SAFETY RECALL

Horizontal Headlamp Adjustment Caps

Reference: A4C / NHTSA 25V-715

2024-2025 (FG) Fiat 500e

Figure 1 – Horizontal Headlamp Aim Adjustment

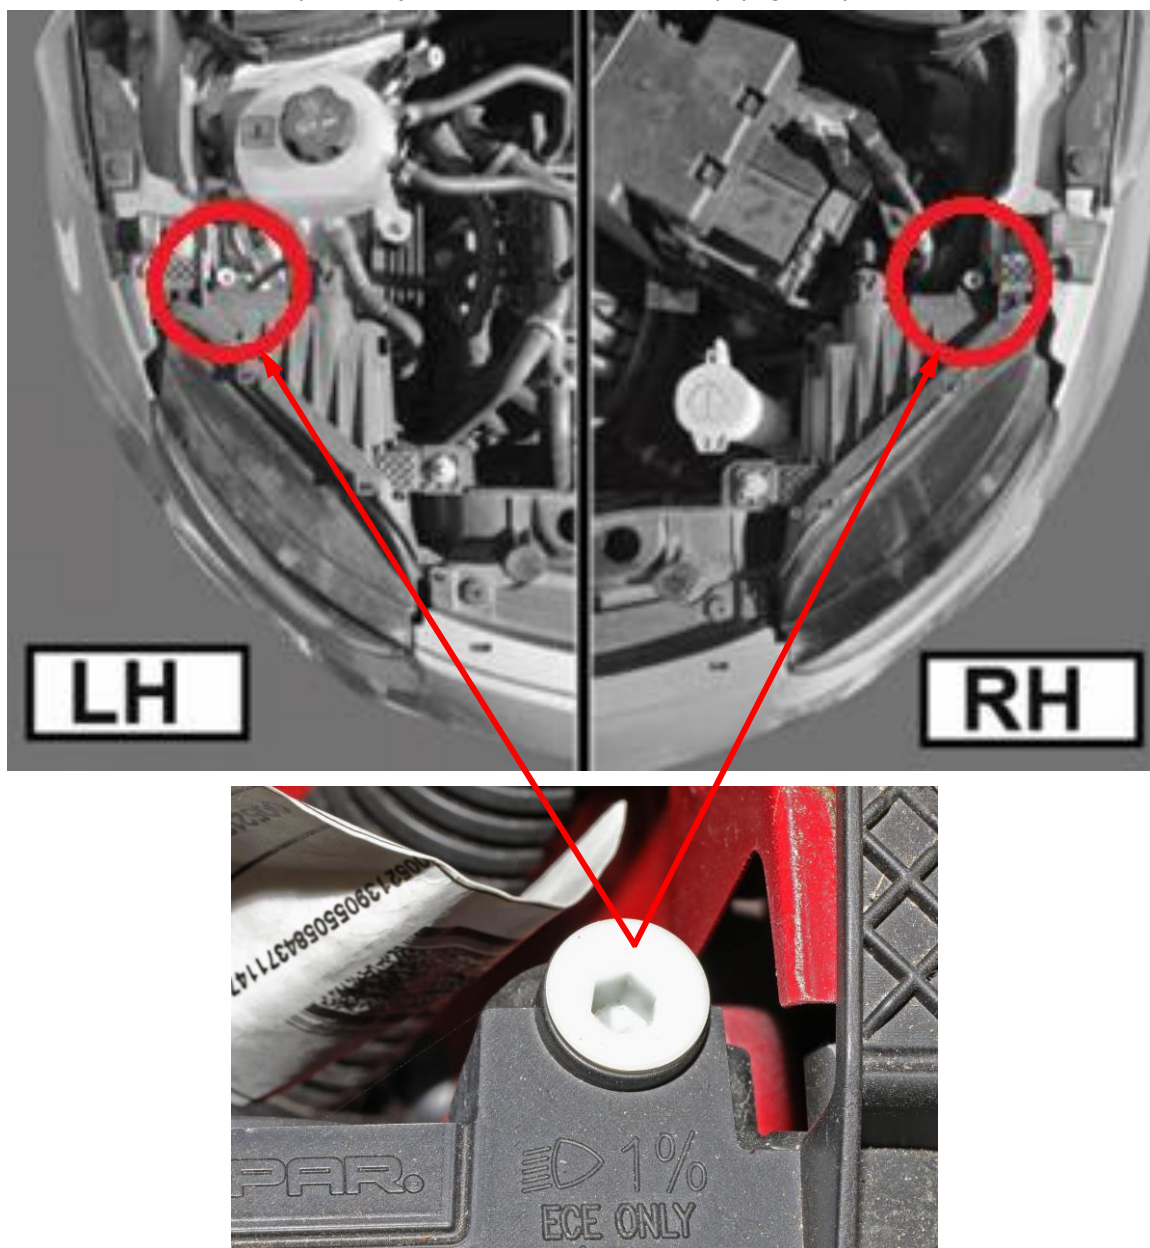
The caps for the horizontal headlamp aim adjustment mechanism on about 2,190 of the above vehicles may be missing. If headlamp aim is improperly adjusted it may reduce forward visibility for the driver and create glare for oncoming vehicle drivers, which may cause a vehicle crash without prior warning.

The condition described above does not comply with Federal Motor Vehicle Safety Standard (FMVSS) No. 108 which requires that "A visually/optically aimable headlamp that has a lower beam must not have a horizontal adjustment mechanism..."

1. Open the hood.
2. Locate the horizontal headlamp aim adjustment for each headlamp (Figure 1).

Install caps over the horizontal headlamp aim adjustments.

3. Add an adjustment cap to each headlamp (Figure 2).
